REQUEST FOR FURTHER INFORMATION - CRC184072; CRC184073; RMA/2019/373

Lands and Survey (South) Ltd have applied for resource consent on behalf of SOL Quarries Ltd to expand their quarry, located at 81 Conservators Road, Yaldhurst.

The purpose of this letter is to provide responses to the questions that have been raised by Environment Canterbury (ECan) and Christchurch City Council (CCC) by way of Section 92 requests for further information.

Figure 1: Proposed Dust Management Plan

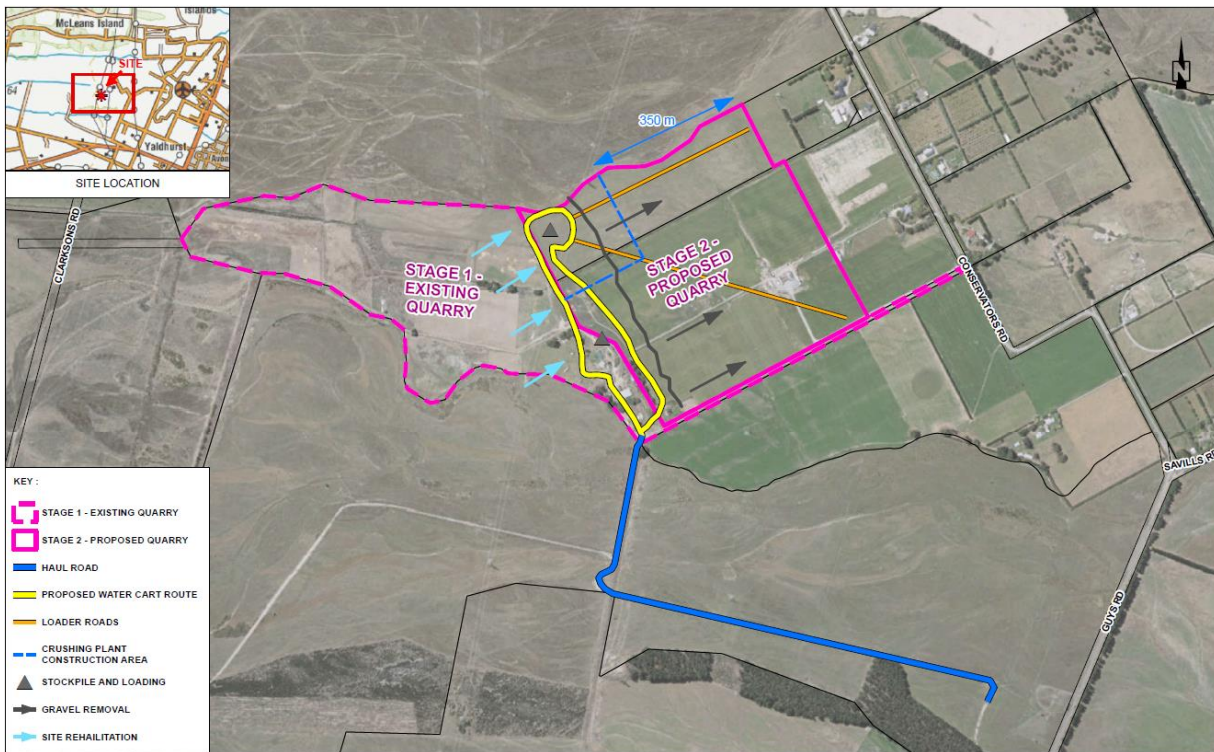
ii. In regard to the surface area that will require dust suppression, please provide clarification on the following matters:

With reference to **Figure 1**, the main haul road length has been measured as being 1.3 km in length from the end of the chip sealed entrance to the weigh bridge. In order to minimise the dust creation potential and consequently reduce dust suppression water demand, the main haul road has been surfaced with crushed used asphalt which has lower dust generation propensity than gravel.

Figure 4: Downwind impact arc for 113 Conservators Road

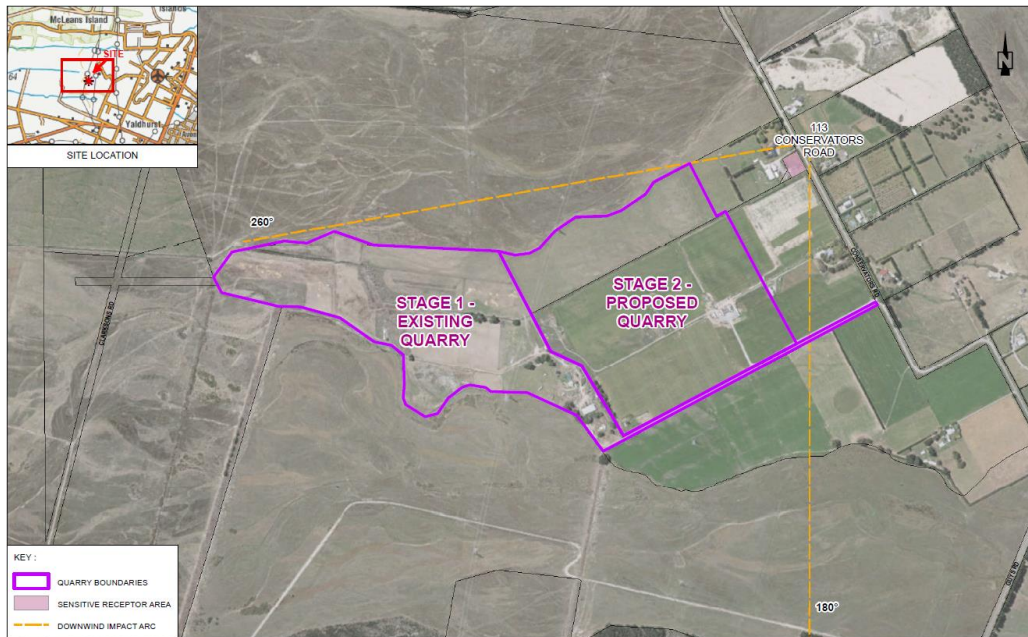
Please provide a more detailed assessment of the potential exposure of the residence at 113 Conservators Road, Yaldhurst to potential dust events from the proposed quarry activity. This assessment should include consideration of any additional mitigation measures to address potential impacts, particularly when quarry operations come within 250 metres of that residence.

Figure 4 shows the location of 113 Conservators Road and the corresponding downwind impact arc relative to the current and proposed operations (including the heavy truck haul road). The residential sensitive receptor at 113 Conservators Road is located to the northeast of the proposed quarry site as shown in **Figure 4**. The downwind impact arc is also shown which indicates the wind directions considered when analysing which winds cause the sensitive receptor to be downwind from the proposed quarrying activities. Wind directions blowing from between 180 and 260 were used for wind analysis calculations when considering this receptor.

Table 1 shows the frequency with which the sensitive receptor identified at 113 Conservators Road is downwind from the proposed quarry. The IAQM guidelines for frequency are based upon the percentage frequency of winds > 5 m/s from the direction of the dust source on dry days. The sensitive receptor at 113 Conservators Road is classified as 'Moderately frequent' under the criteria defined in IAQM (between 5% and 12%).

Figure 6: Frequency of wind speeds >5 m/s on dry days blowing towards 113 Conservators Road in summer

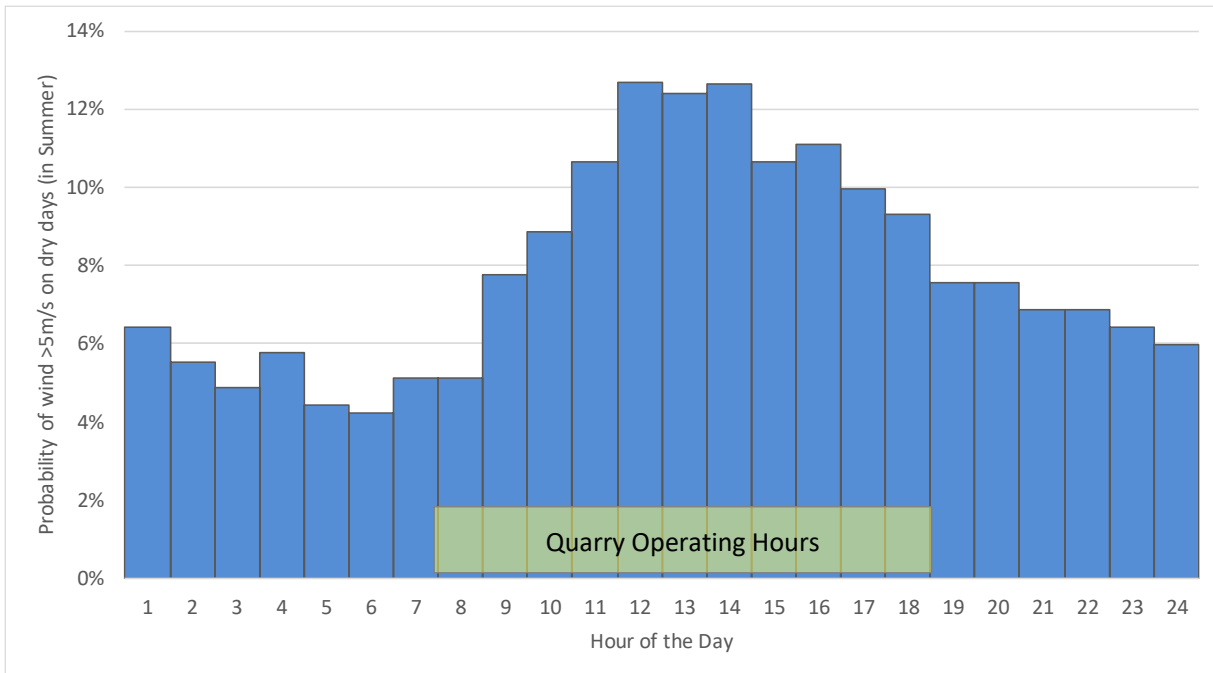
- i. *Based on the above, please clarify what is considered to be a more reasonable water application and provide an updated assessment regarding the use of water for dust suppression. In this consideration, please include water that will be consumed during*

Based on the wind speed data analysis above (see **Figure 6**) PDP also suggests that SOL Quarries' dust management approach could be amended to focus water application for dust suppression to the hours when wind speeds are greater than 5 m/s i.e. in the 6 hours in the afternoon. If the full 100 m³ of available water were used for dust suppression during this time, this would increase the potential intensity of water

Figure 15. Location of the meteorological monitoring site (blue circle) and indicative area for the PM₁₀ monitoring (red circle).

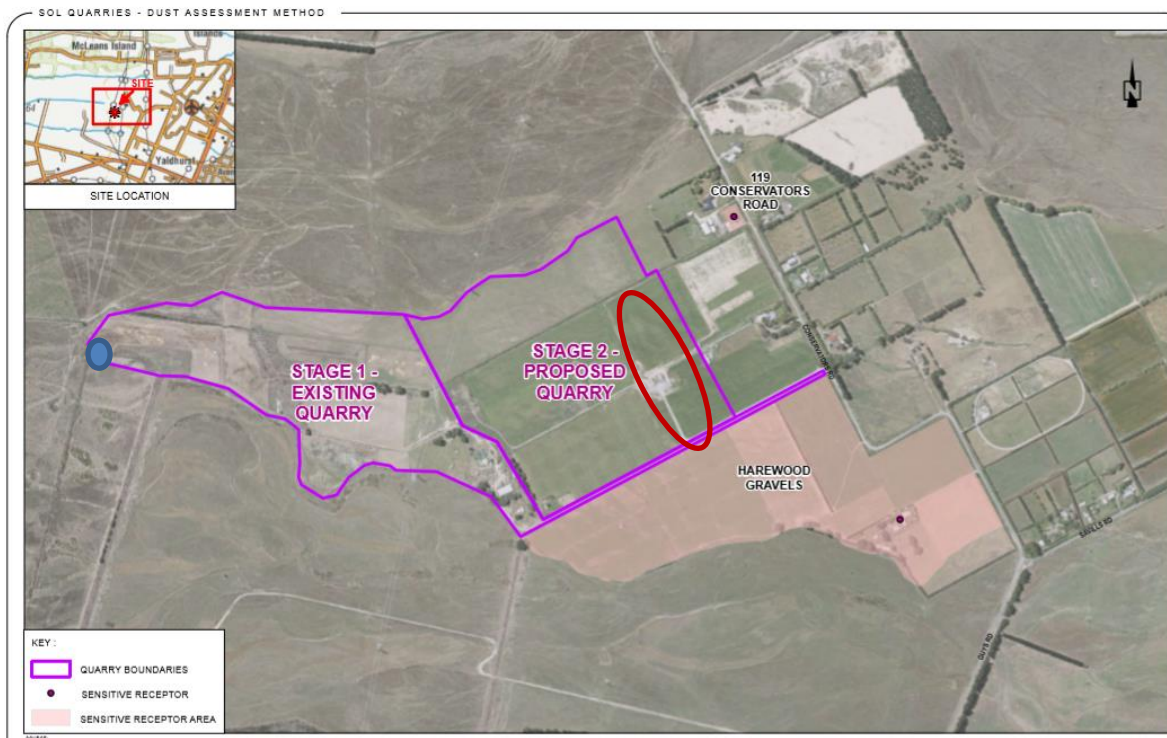
The Air Quality Assessment indicates that monthly PM₁₀ and Total Suspended Particulate (TSP) monitoring will be undertaken on the northeast boundary of the site to demonstrate the effectiveness of the control and mitigation measures. It is stated that detail of this is provided within the 'Draft Dust Management Plan'. However, no details of this have been provided. Please provide:

One of the key elements of SOL Quarries' air quality monitoring programme is a 10 m high meteorological mast carrying windspeed, wind direction, temperature and relative humidity sensors. A rain gauge is installed alongside the meteorological mast. The meteorological mast has been installed on site and is located on the western boundary of the site. Because of the surrounding flat terrain while it is located on the western end of the site the instruments will provide data that is representative of conditions being experienced across the entire site. The meteorological sensors on the mast are currently not fully functional but a complete maintenance service and re-calibration is scheduled for the site in the near future. The data from the meteorological site is telemetered via a cellular network to Harvest.com where it is available for real-time viewing and analysis on that website.

The second key element to SOL Quarries' air quality monitoring programme will be a PM₁₀ monitor. The PM₁₀ monitor is likely to be a nephelometer (light scattering) instrument which provides real-time PM₁₀ measurements which along with the meteorological data be telemetered to the Harvest website. The PM₁₀ monitor will be set up on a steel frame and be powered by batteries which are recharged by solar panels. This configuration allows the PM₁₀ monitor to be quickly and easily relocated (within say 2 hours) to capture PM₁₀ concentrations when the wind is blowing toward nearby sensitive receptors.

Figure 17 shows the location of the meteorological mast (blue circle) and an indicative area (red circle) within which the PM₁₀ monitor is most likely to be operated to capture PM₁₀ concentrations. **Figure 17** shows a photo of the PM₁₀ monitor set up.

Figure 17: 1-hour average PM10 concentrations at Site 1

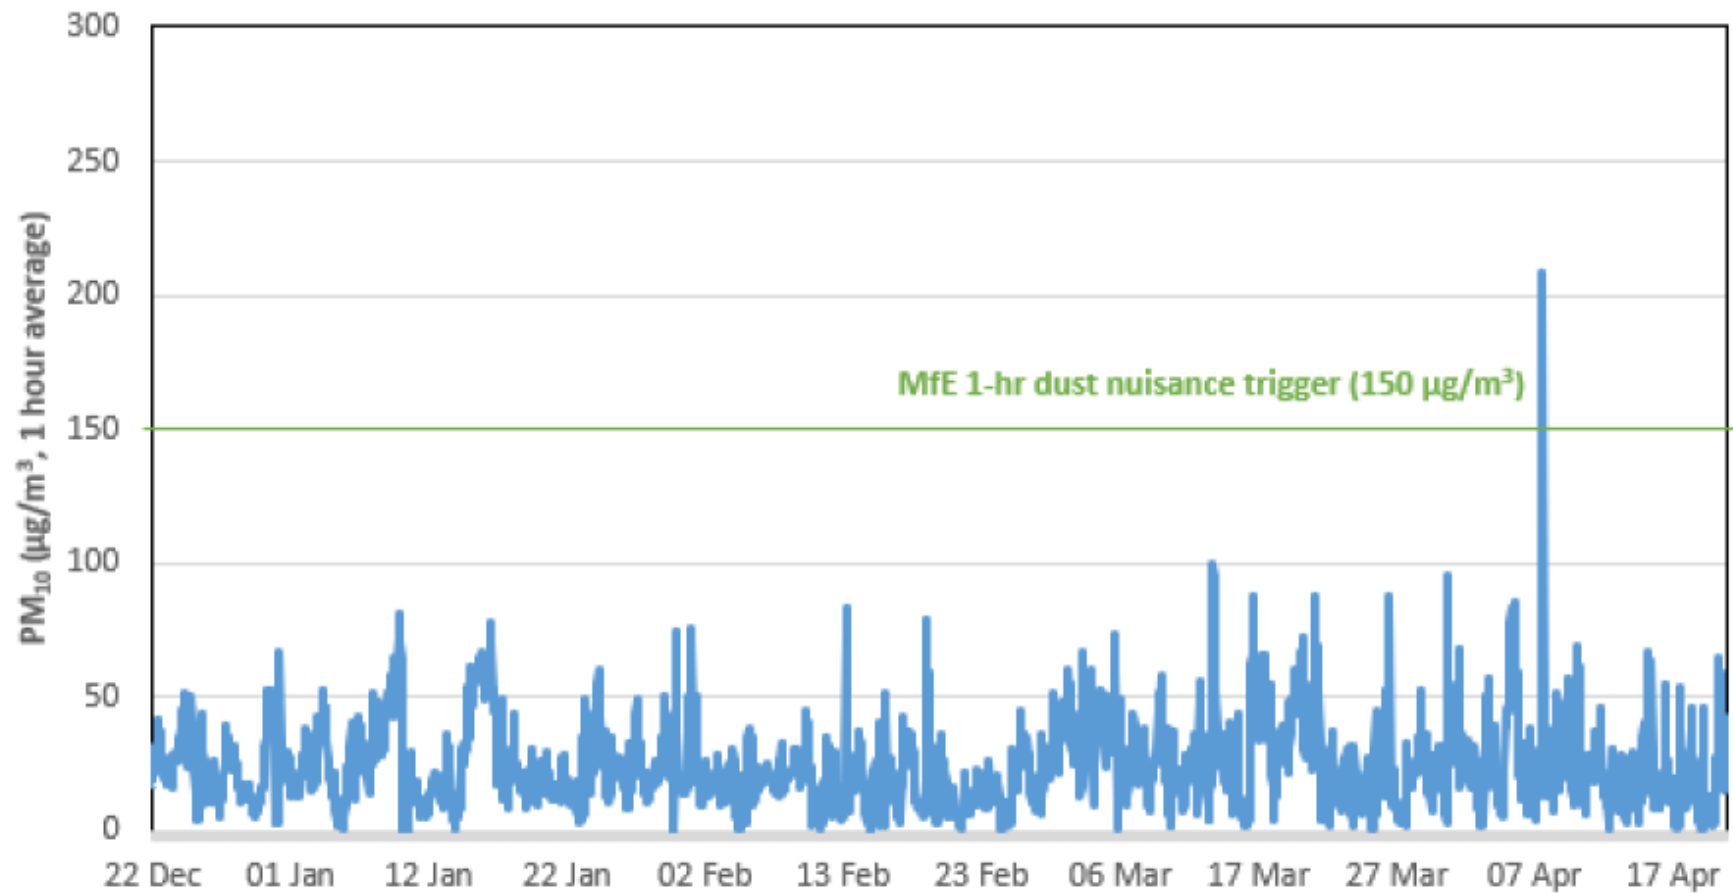
Please provide details of the existing dust levels at the nearest residential properties. This will require dust monitoring on a number of days with different weather and wind conditions.

The 1hr average PM₁₀ concentrations at Site 1 are shown below in **Figure 17** which had been reproduced from the Mote report (originally Figure 5 on page 13).

It can be seen from **Figure 17** that the MfE 1-hour dust nuisance trigger value of 150 µg/m³ was exceeded twice on Saturday the 7 April 2018. These exceedances occurred at 8.00pm-9.00pm and from 9.00pm-10.00pm New Zealand Standard Time. Both these periods are outside the operating hours of the quarries and occurred when a northerly wind was blowing i.e. not from the direction of the quarries.
